City of Portland, Maine – Building or Use Permit Application 389 Congress Street, 04101, Tel: (207) 874-8703, FAX: 874-8716

BUILDING PERMIT REPORT

20 Sept. 99 ADDRESS: 108 Westminster Ave. CBL: 181-B-012
 SON FOR PERMIT: 9'x10' Sunroom 6'x5' deck
 BUILDING OWNER: John Gray
 PERMIT APPLICANT: Contractor American Profiles
 USE GROUP R-3 CONSTRUCTION TYPE 5B

SECTION 'A'

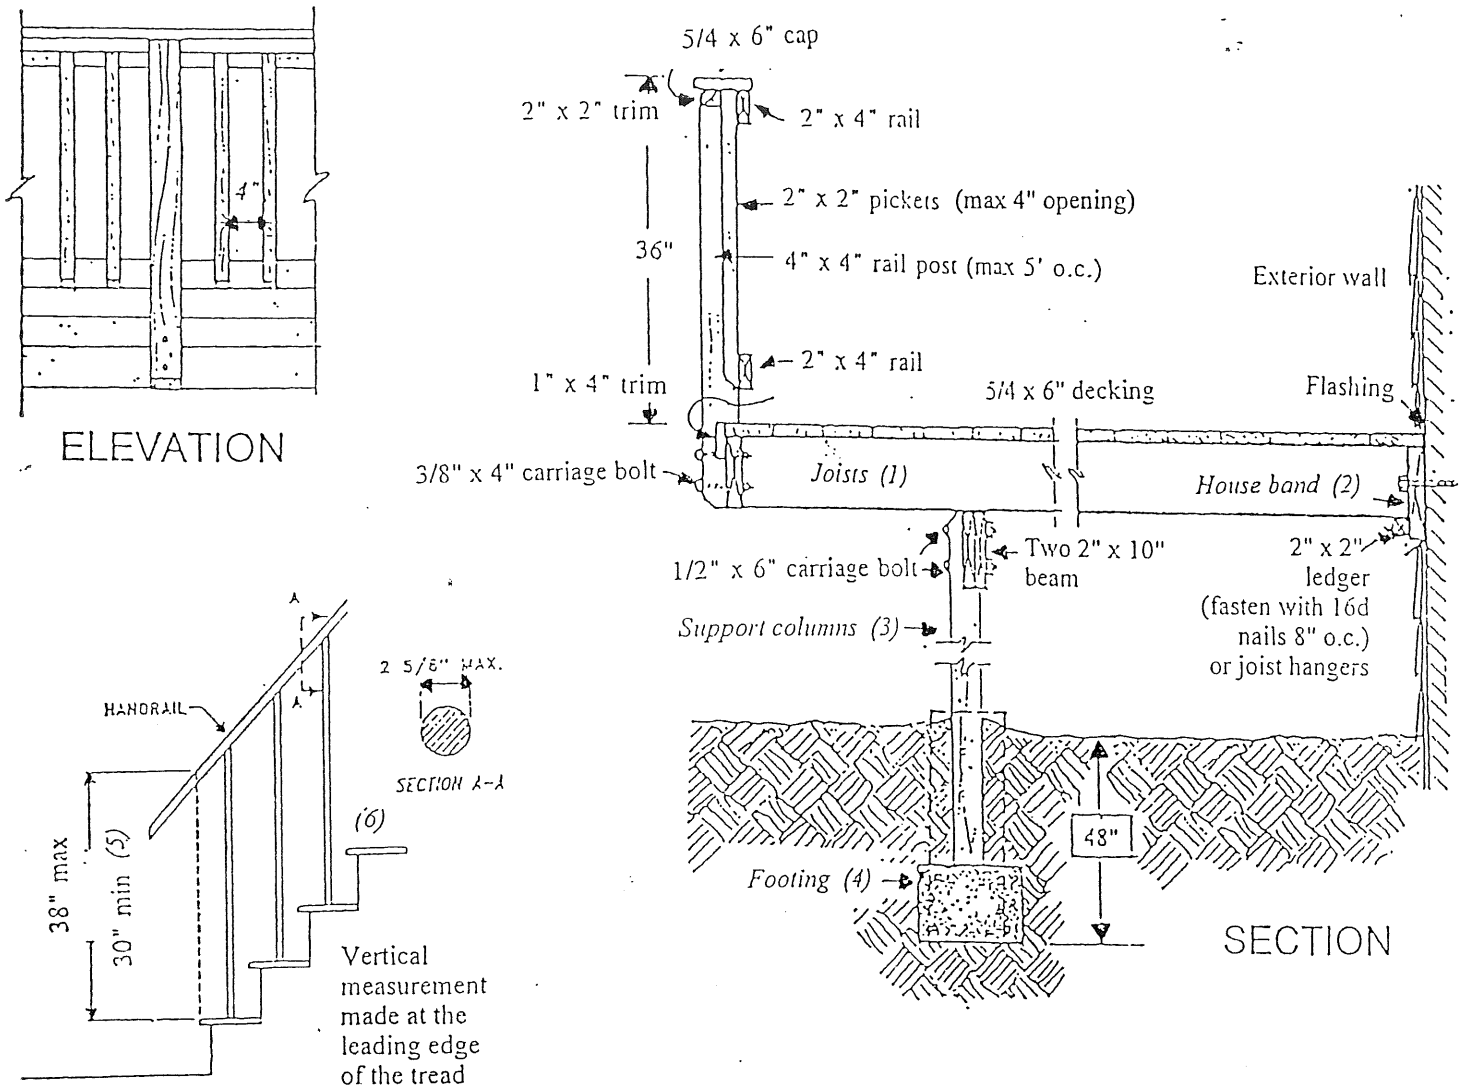
check bearing

- *35. *The proposed pier Foundation shall be placed on Footings with Fasteners between The Two. Also Fasteners shall be used between piers and columns & deck Framing.*

- A36 *Care shall be Taken in where The Two roof Framing members Connect - the proposed roof shall have full bearing on The Dwellings wall.*
